ADDENDUM

PROJECT: University of South Dakota
Patterson Hall
Mechanical / Electrical Infrastructure Upgrades
Vermillion, South Dakota

AD-1

DATE ISSUED: Thursday, January 22, 2015

SHEET NUMBER: **A-403**

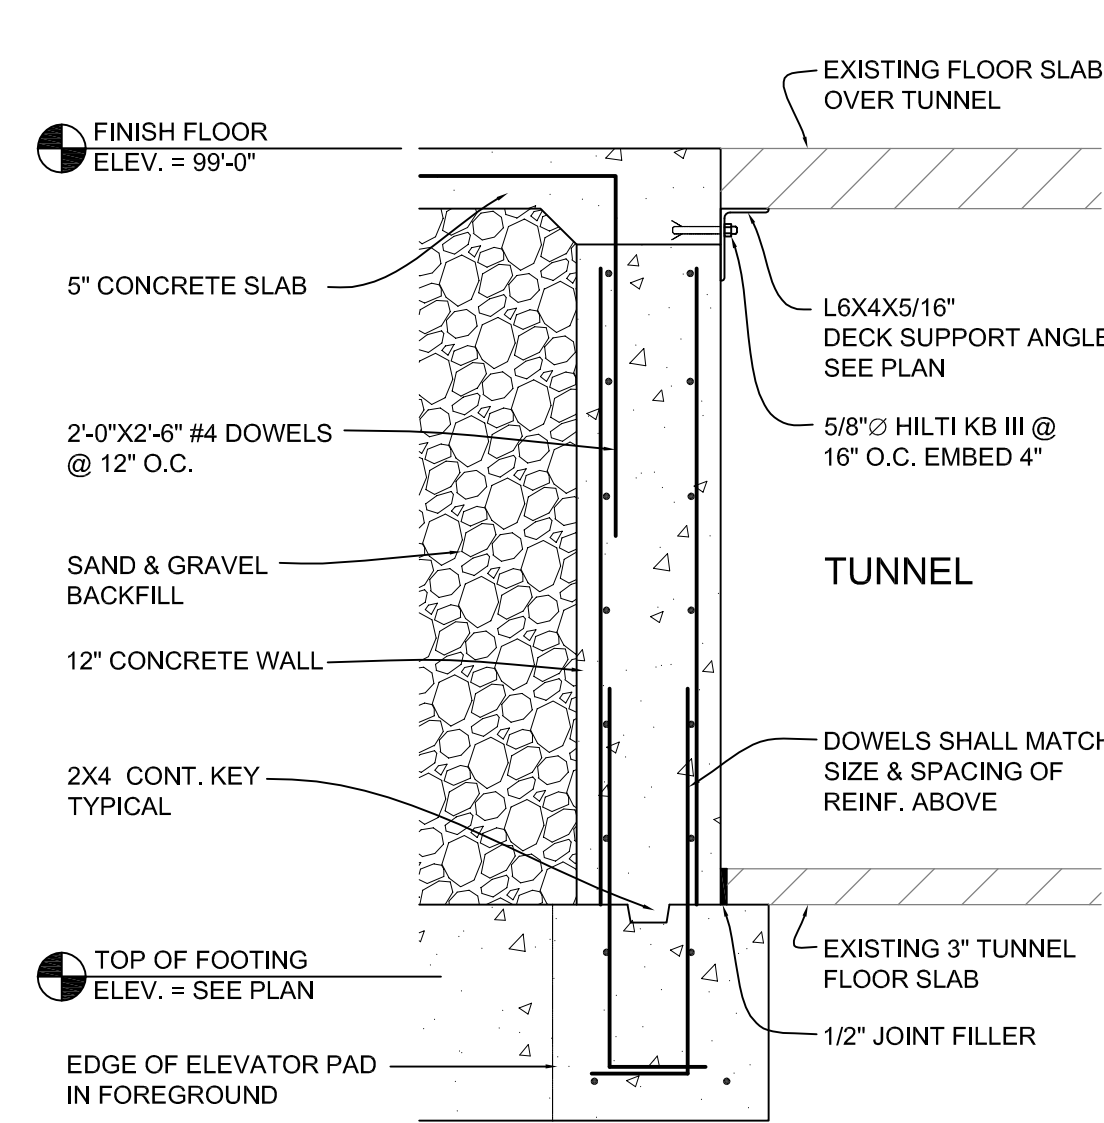
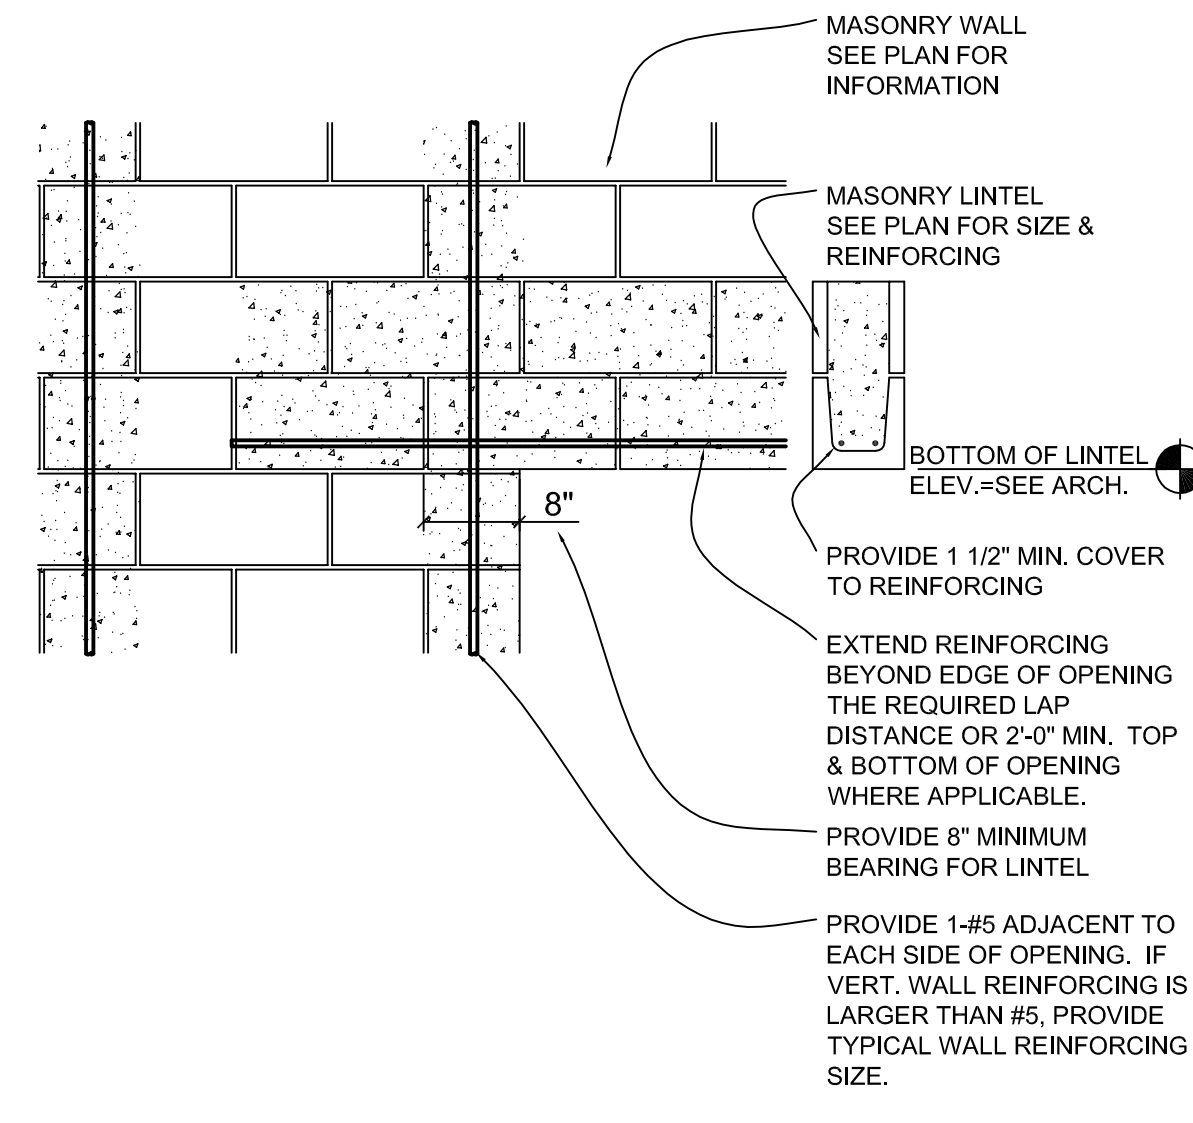
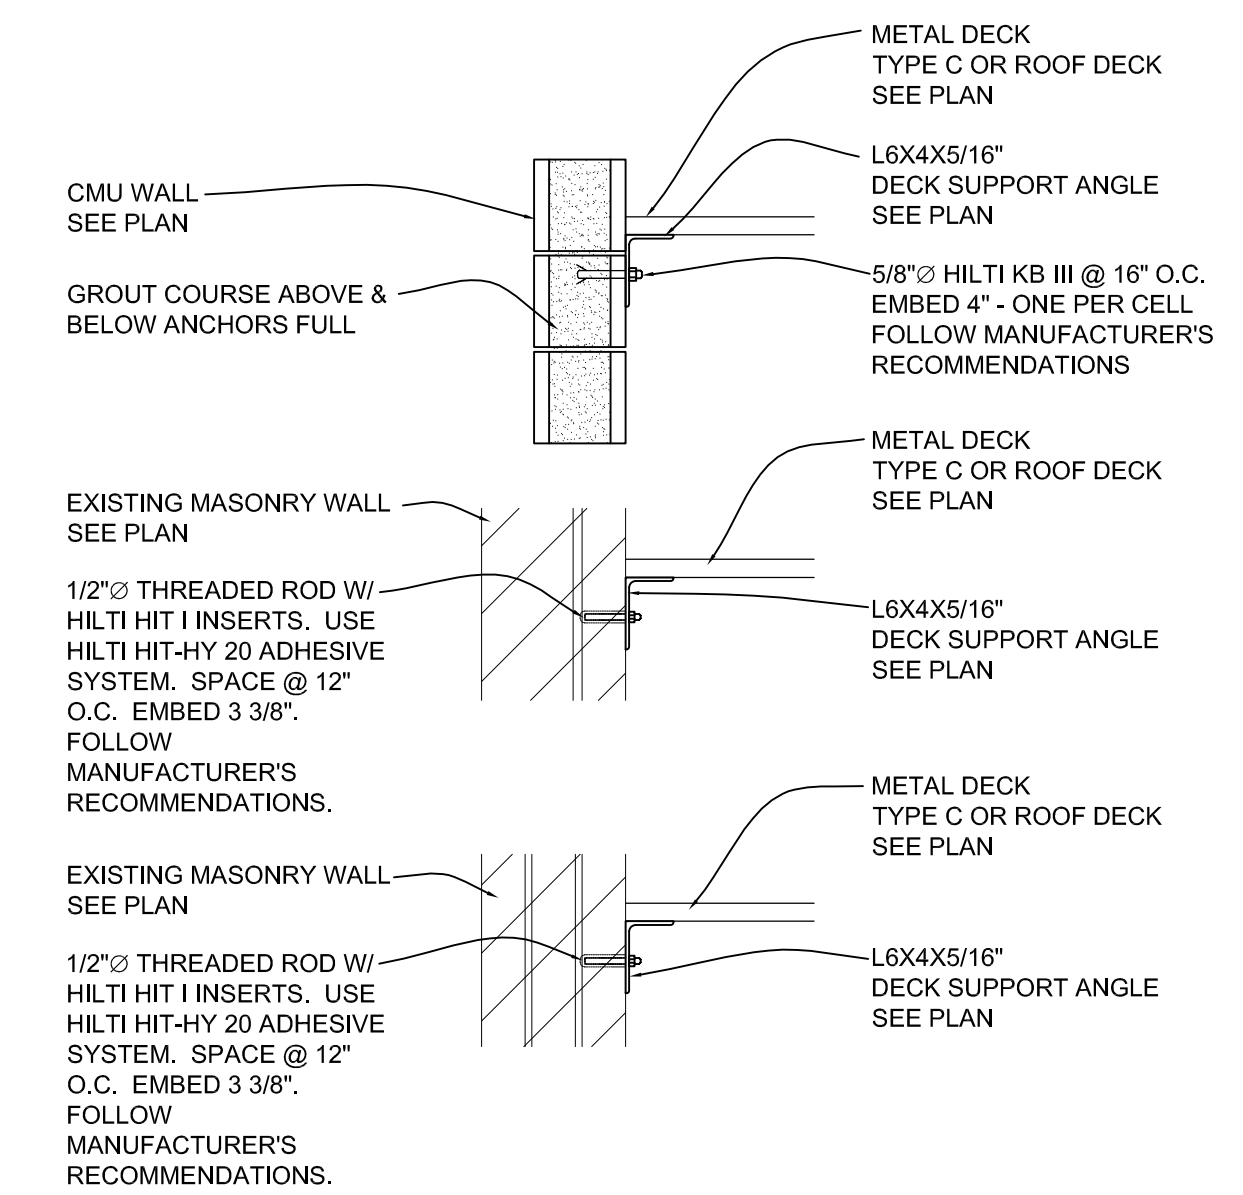
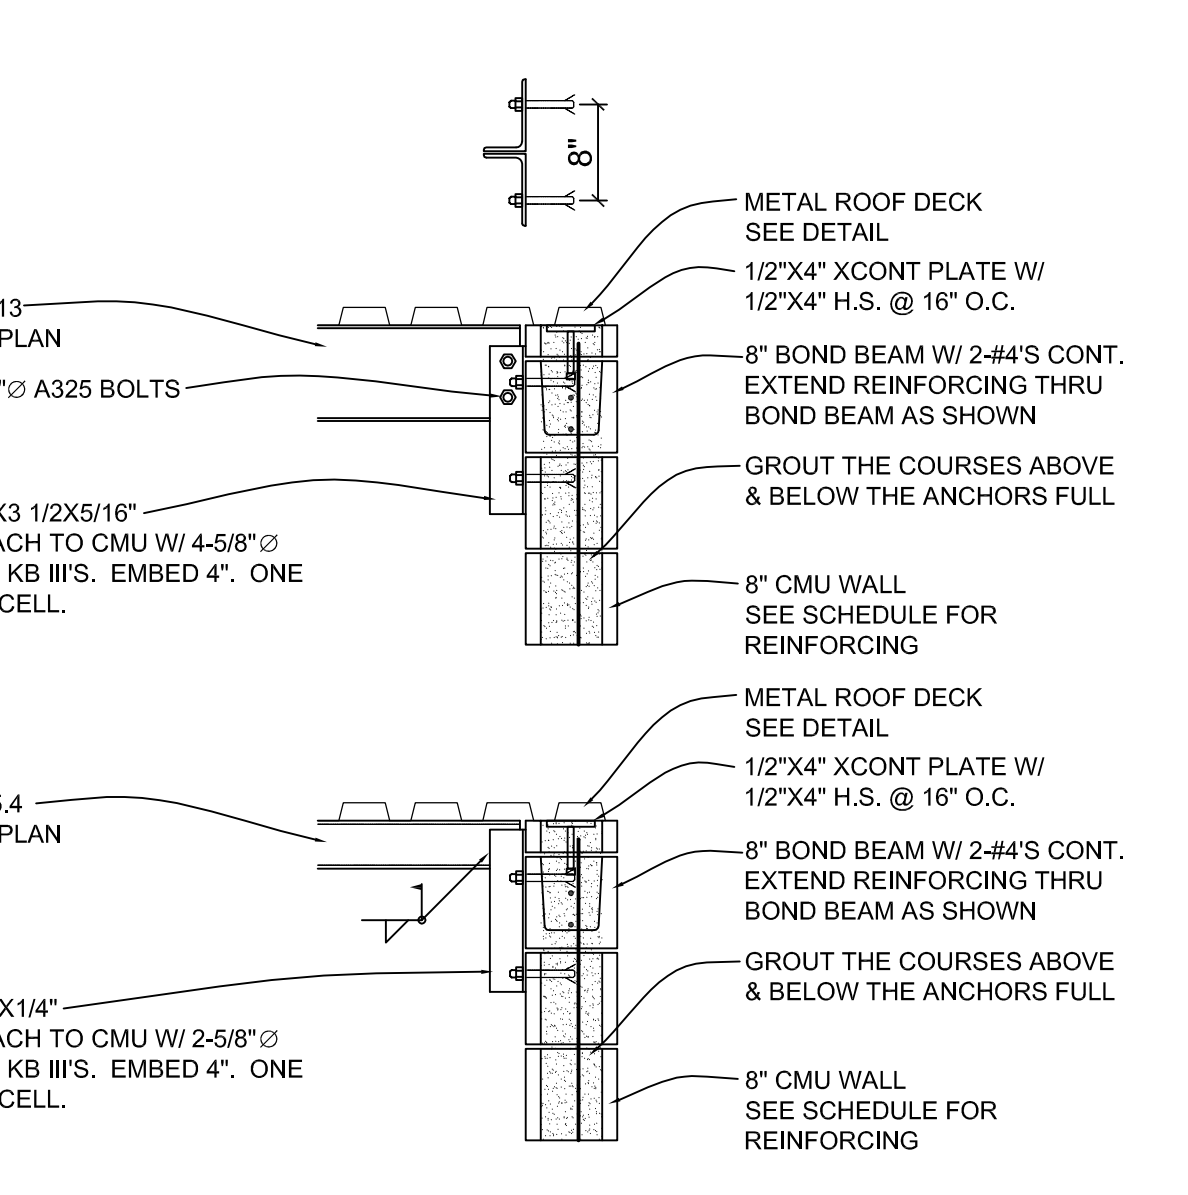
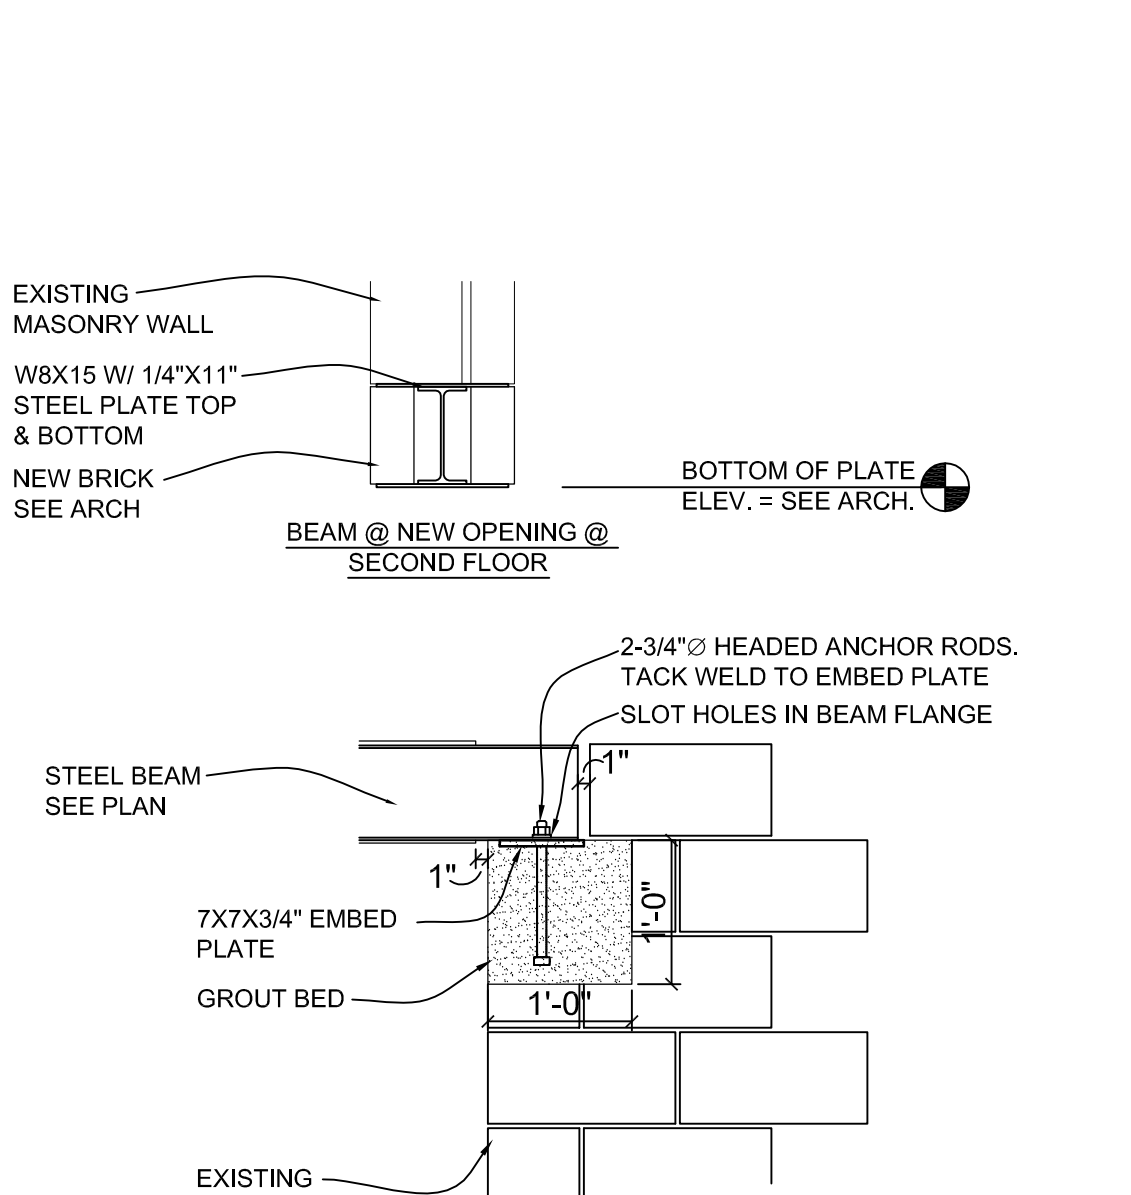
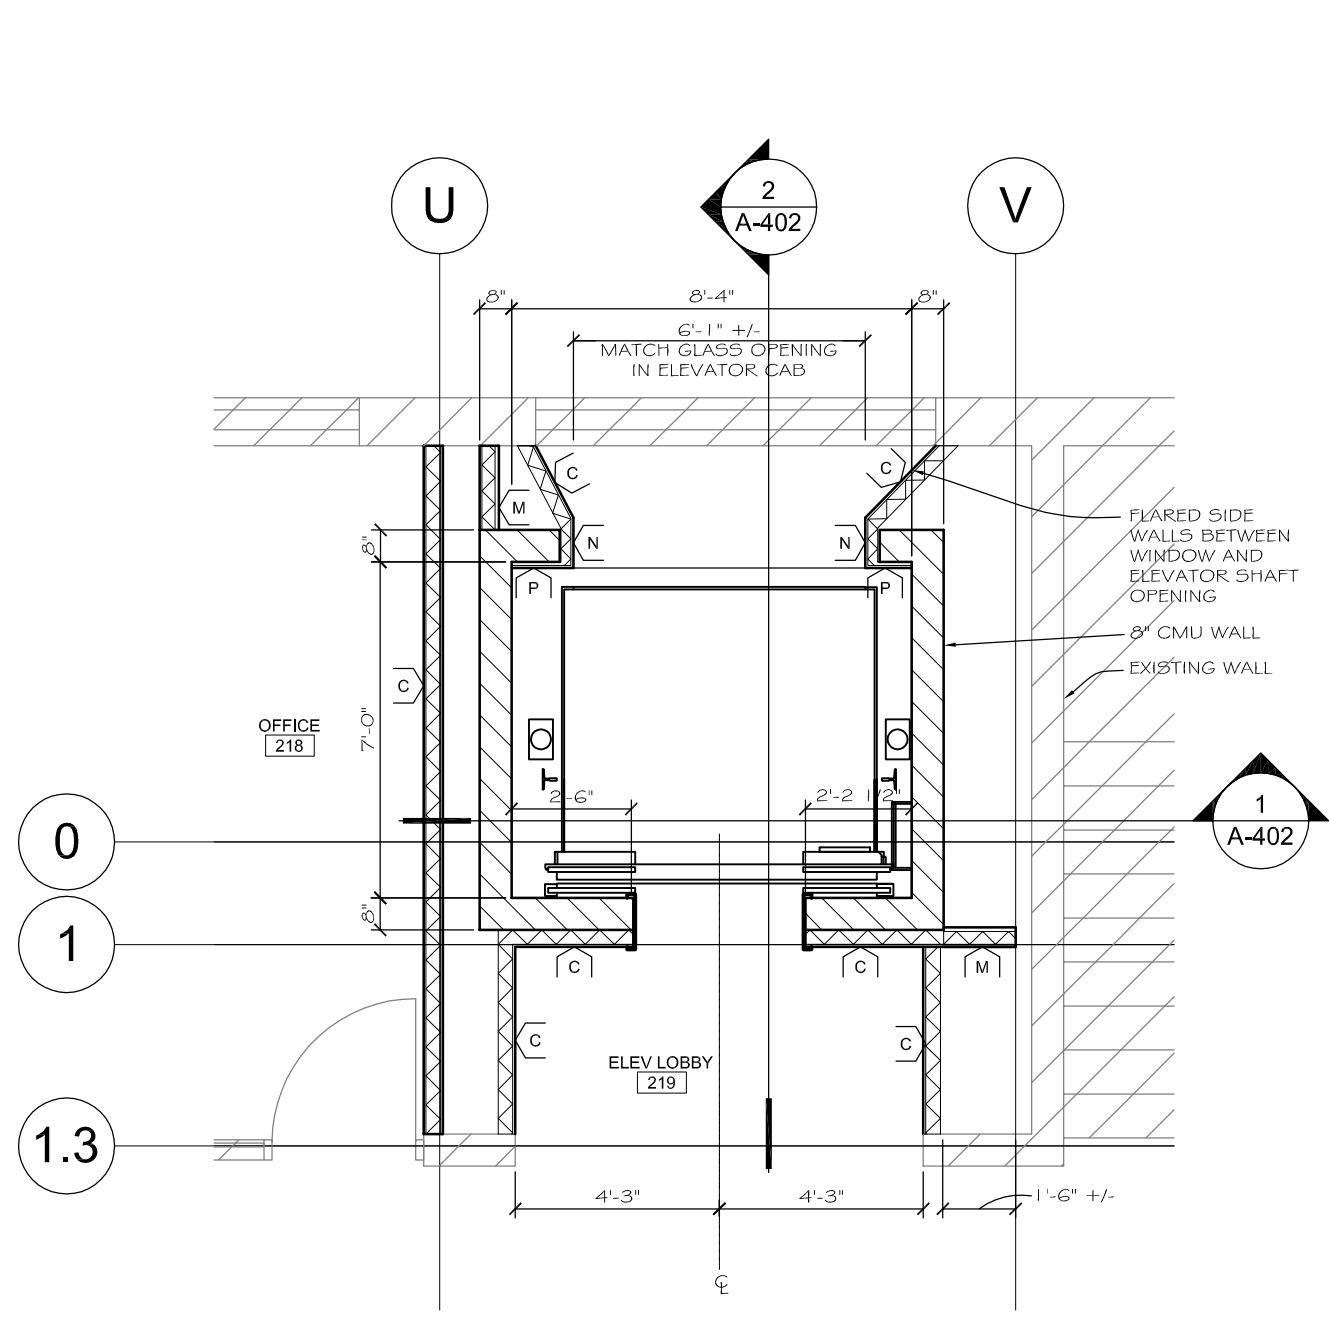
In reference to Sheet A-403, see attached revised sheet.
